Interactive comment on “The formation processes and development characteristics of sandbars due to outburst flood triggered by landslide dam overtopping failure” by Xiangang Jiang et al.

Response to the Reviewer 2 Summary: The authors use a flume study to understand the effects of outburst flooding on downstream sandbar development. Different dam geometries (width and downstream slope angle) and a constant dam height were used. The upstream pool was allowed to fill and then overtop and fail under the same constant flow rate in all experiments. The authors relate bar frequency and volume to different dam geometries, and also note that bars tend to grow upstream during the experiments. The authors proceed to relate their observations to the flow hydraulics and sediment concentrations during the experiment. While the experimental set up seems

Fig. 1.

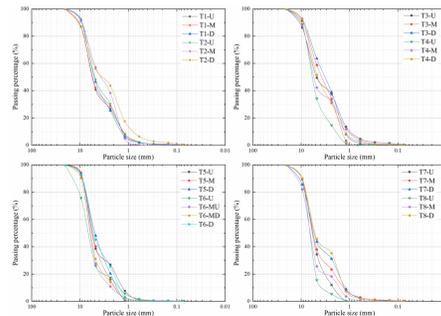
Section 5: given the unknown equation to calculate sediment concentration, and uncertainty in the calculation of sediment transport capacity described above, I don't know how to interpret the results of this section.

Thanks a lot for the reviewer's comments. After our careful discussion, we decided to delete section 5 from the original manuscript. In the revised manuscript, we compared the experimental results with Yigong case and discussed the reliability of experimental

results in section 5. The section 5 in the revised manuscript is as follows: " 5. Discussion The field data of the Yigong landslide dam are used to verify the reliability of the results in this paper. Turzewski et al. (2019) investigated the boulder bars in the Yigong River triggered by the Yigong landslide dam outburst flood in 2000. They found that the number of boulder bars is about 0.69 to 0.77 times the ratio of river bed length to dam length for the boulder bar frequent region. In this study, boulder bars were distributed in the 8 m length of the channel, which is 4 to 7 times of dam length. It reflected the number of boulder bars was 0.4 to 1.0 times the ratio of river bed length to dam length. By comparing the experimental data and the field data of Turzewski et al. (2019), it can be found that field data falls within the range of experimental data. Experimental models took more influence factors into account in this paper, while the field data of Turzewski et al. (2019) only focused on the Yigong landslide dam case. This may be why the field data range is smaller than the experimental data in this paper. Wu et al. (2020) classified the boulder bars in the downstream reaches of the Yigong River into three types according to their shapes and used the length to width ratio as the indicator of a bar shape. The 16 boulder bars in the downstream reaches of the Yigong River have a length to width ratio of 2.5-15. As can be seen from Fig. 9, the length to width ratio of the boulder bar formed in this experiment is in the range of 7 to 16, which indicates the field data could prove the experimental results.
